Re: SEC Docket No. 2015-05: Public Service Company of New Hampshire d/b/a Eversource Energy ("PSNH") and New England Power Company d/b/a National Grid ("NEP"): Joint Application for a Certificate of Site and Facility for the Merrimack Valley Reliability Project – Pelham Substation Tap Line Relocation

A. Background on Proposed Relocation of Structures P-1 and P-2

400298-C-R-306

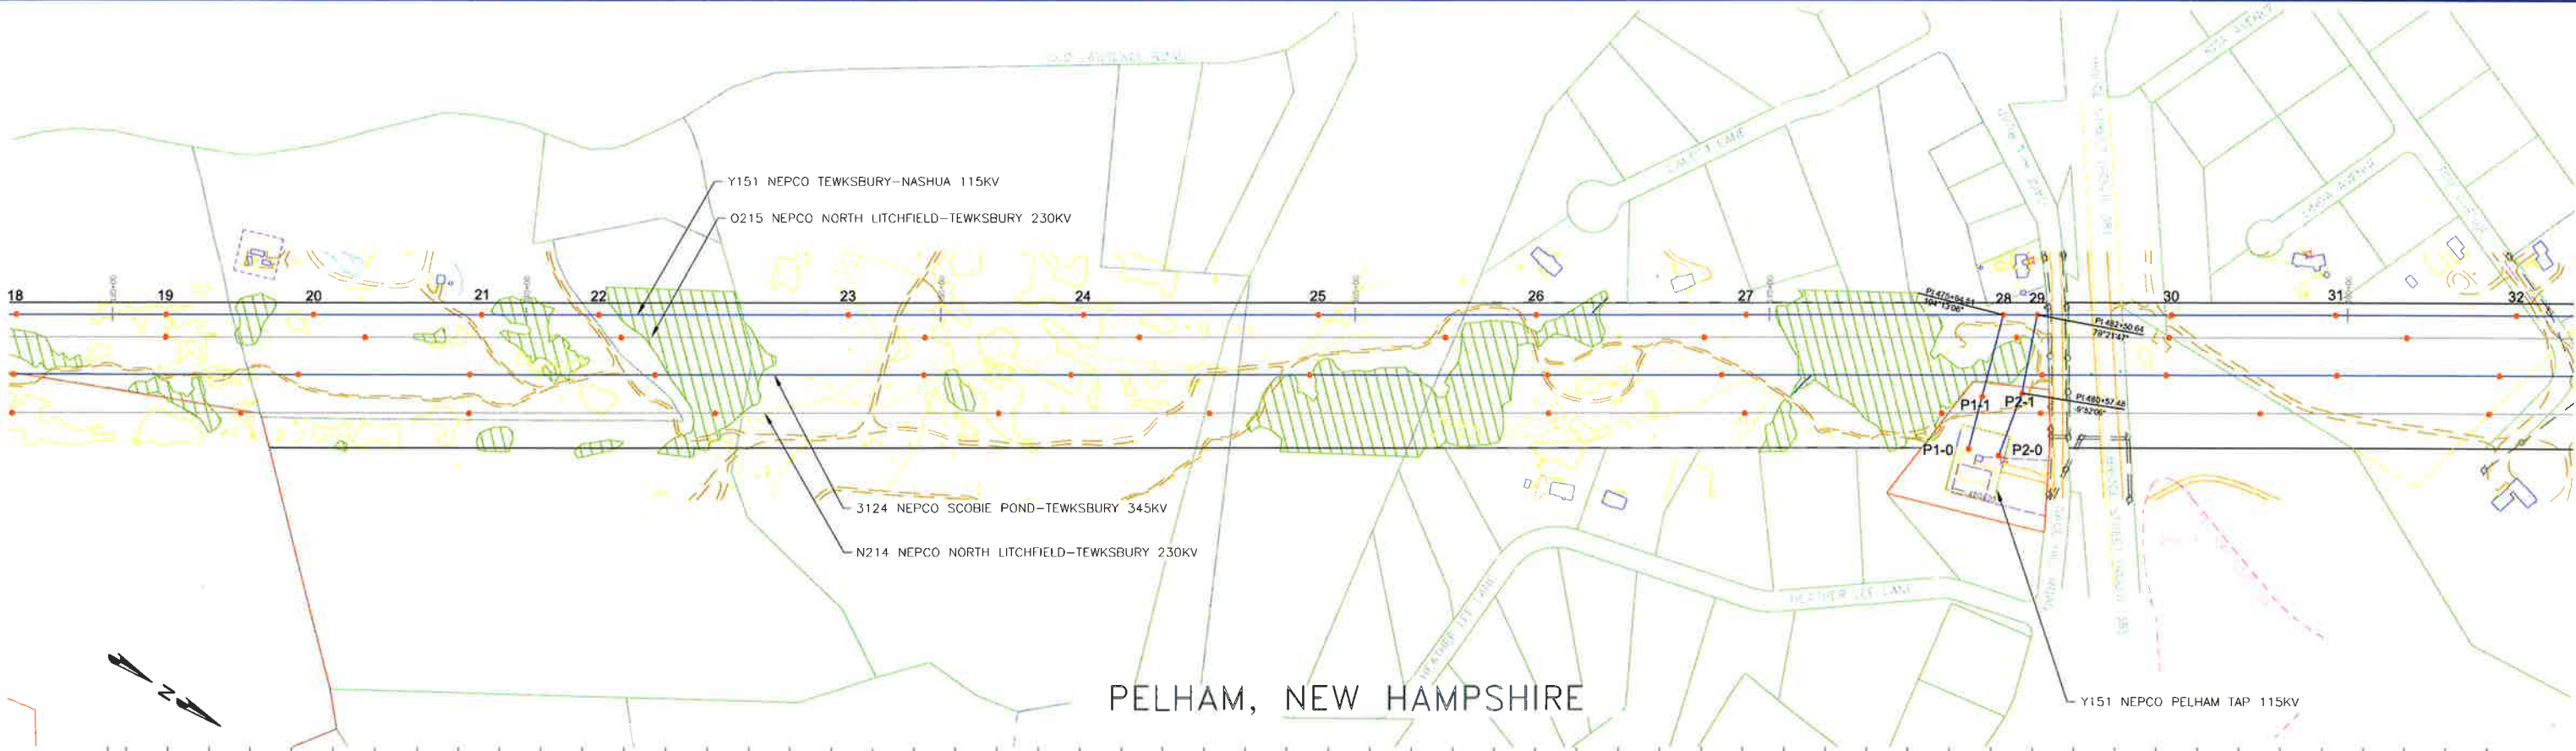
Importantly, NEP only needs to relocate Structures P1-1 and P2-1; the structure type, design and height will all remain the same. The structure heights, final design, and structure type included in the SEC Application conform to structure drawing 400298-C-S-19, originally submitted with the Application at Appendix R and updated in the Applicants’ Supplemental Summary, dated February 19, 2016, at Attachment Q, Revised NEP Engineering Drawings. See Attachment B.

Date: 2/21/2017

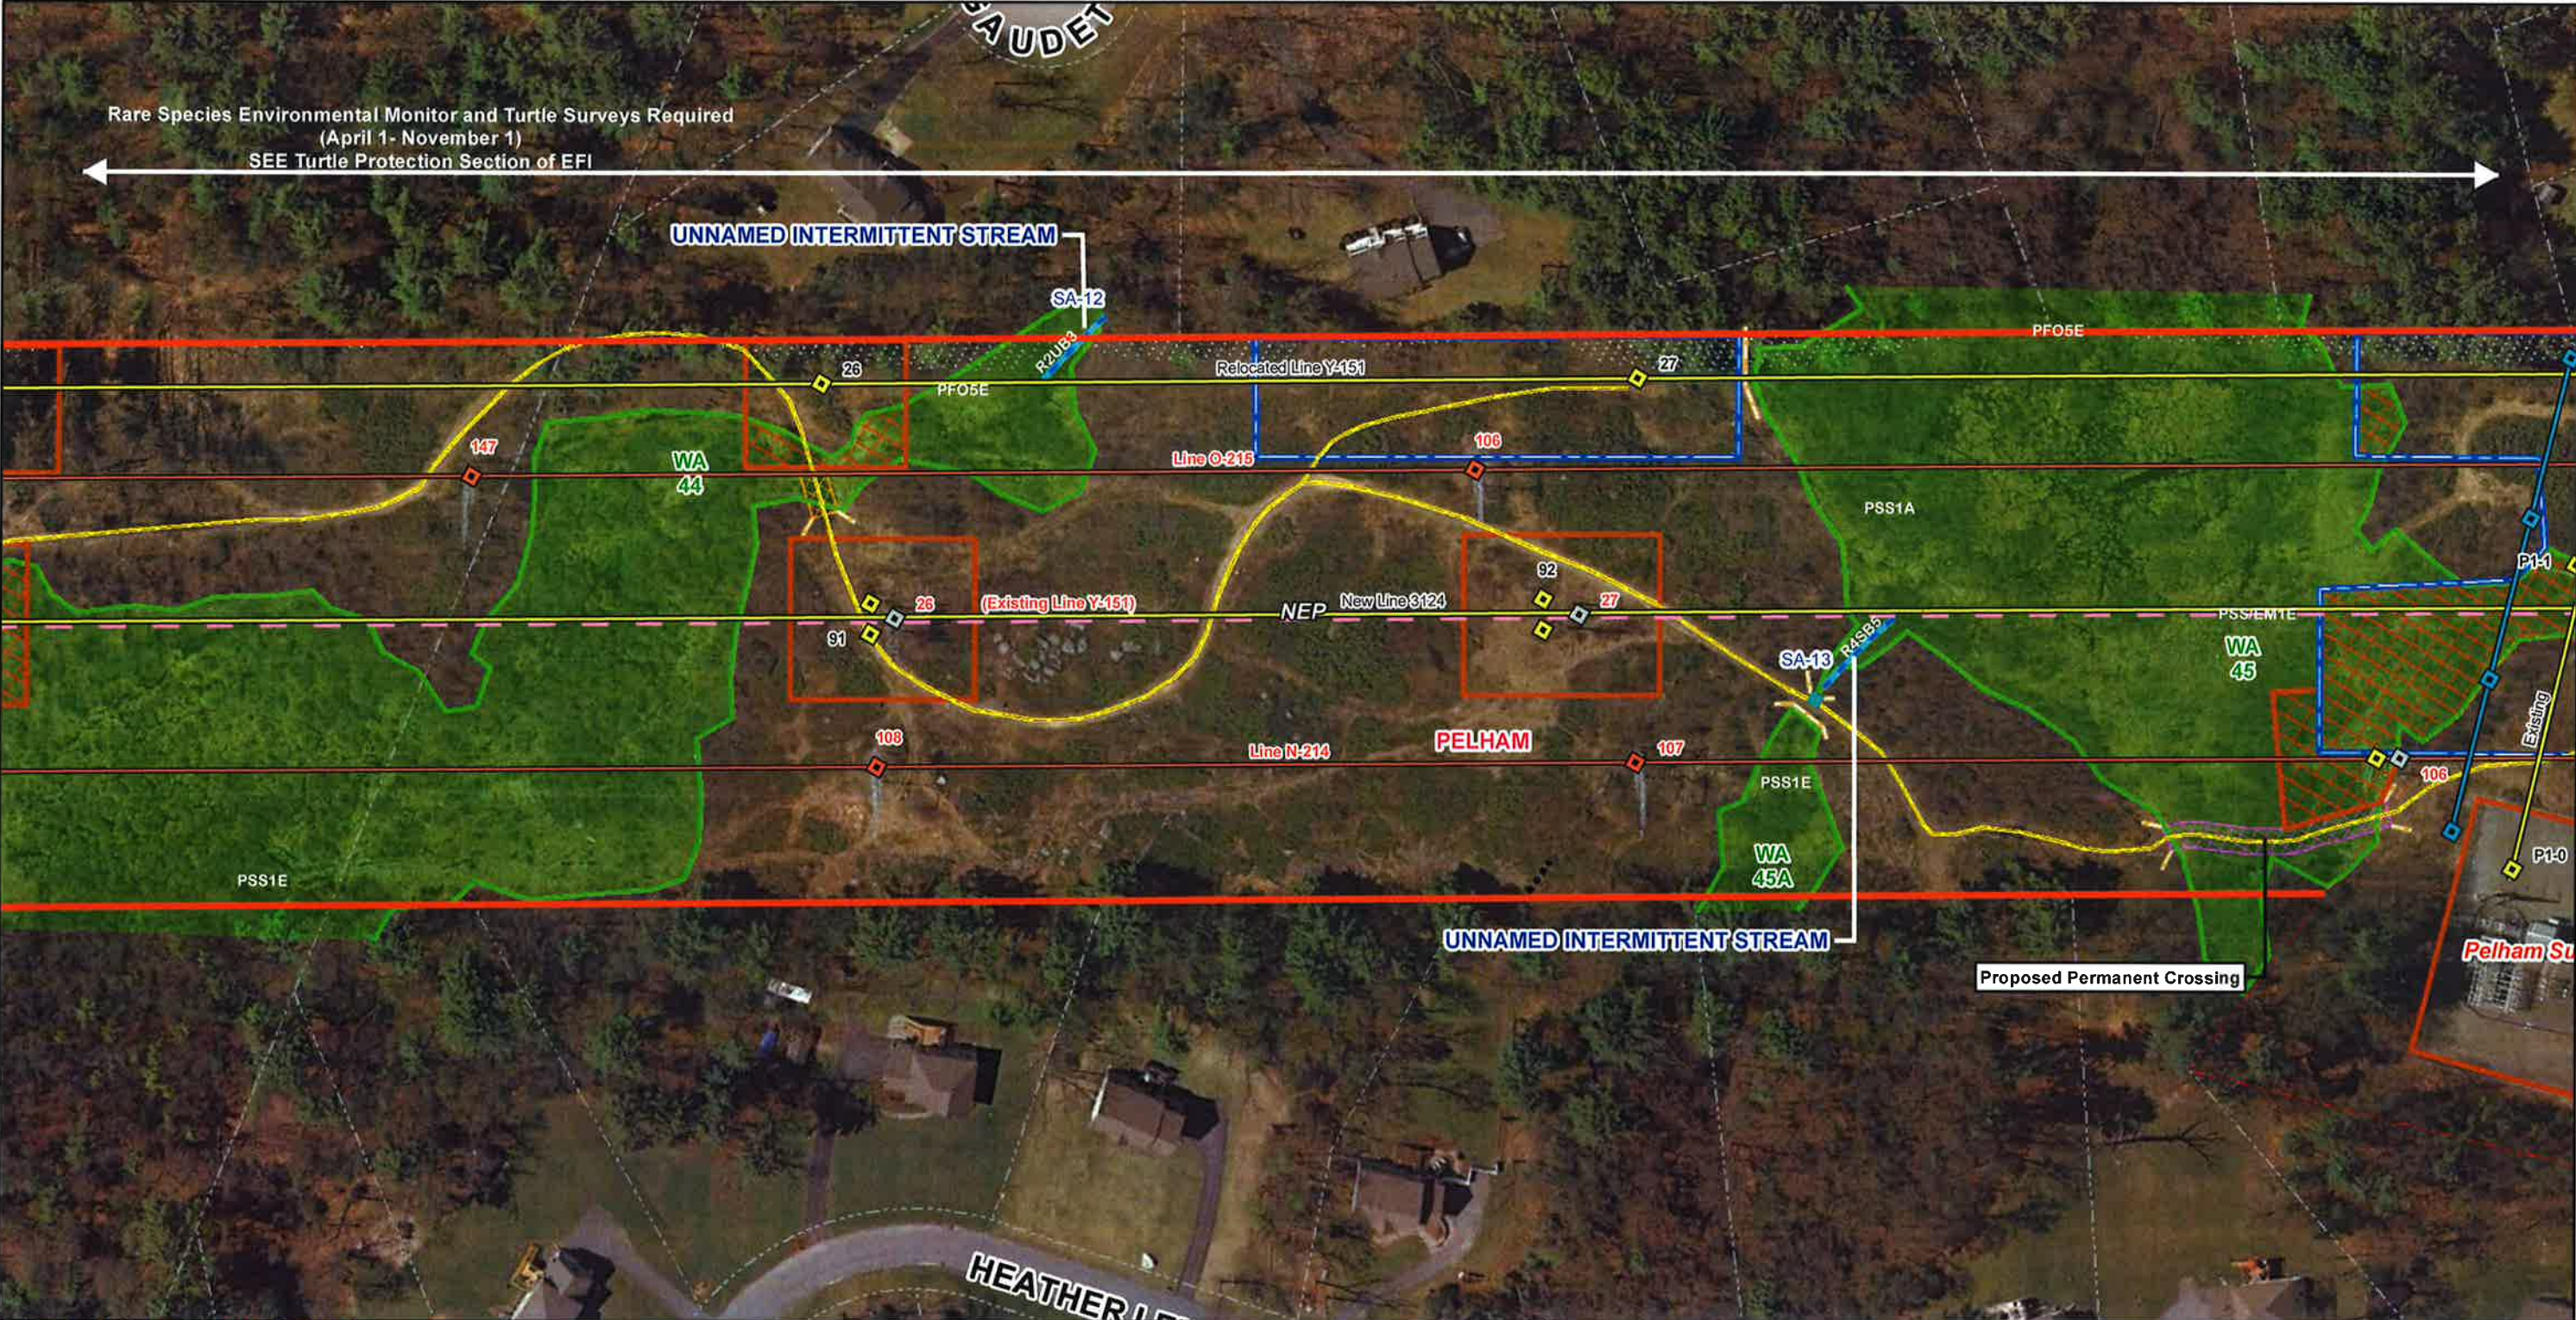
More specifically, the Tap Line project involves the installation of three new Structures: a second terminal structure (P2-0) within the Substation fence and two new supporting structures within the ROW (P1-1 and P2-1). See Attachment A and B. Terminal structures P1-0 and P2-0 will remain as shown in the MVRP Application for a Certificate of Site and Facility; however, Structures P1-1 and P2-1 were originally located east of Wetland 45. Refer to Attachment E for proposed location of tap line structures.

Following the administrative proceeding for MVRP, the design of the Pelham Substation expansion evolved to include a retaining wall on the western perimeter of the expanded substation to maintain a level substation yard. The overall footprint of the substation yard expanded as part of the permit approvals received locally from the Town of Pelham. Once the Pelham substation expansion design was complete, the height of the retaining wall and associated fencing also increased in order to maintain access to the right-of-way. As a result, the Tap Lines as designed would no longer comply with the safety clearance standards required under the National Safety Electric Code (“NESC”). In order to achieve the necessary clearances, NEP has to relocate Tap Line Structure P1-1 approximately 64 feet to the west and Structure P2-2 approximately 43 feet to the west, from the locations originally proposed outside of Wetland 45 to within Wetland 45. Compare Attachment A with Attachment E.
